Caen Hill Pumping Station

PHASE 2 SITE TEST SUMMARY REPORT

Report No: 10031024-00536

Work Package: Trialling Emerging Technologies (Canal & River Trust) I1

Figure 15 – Example of suction cone to improve inlet hydraulic stability

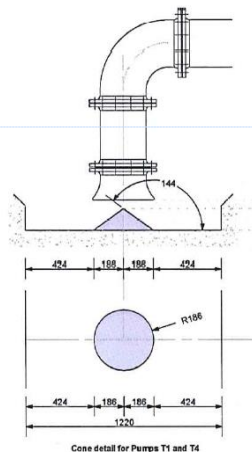
Commented [BK3]: We mention bellmouth / suction pipe diameters also being a contributory factor to this. Is there anything we can do to improve that, eg taper d/s of bend, then upsize bend dia and bellmouth dia? If not, then also probably worth stating this and explaining why - ie perhaps considered would have negligible impact vs the length thru the wall and bolted to the pump inlet.

Commented [JN4R3]: The sizing is a red herring and removed not that the comparison has been made. The scope of the changes as I see would be to lower the bellmouths and add a suction cone.
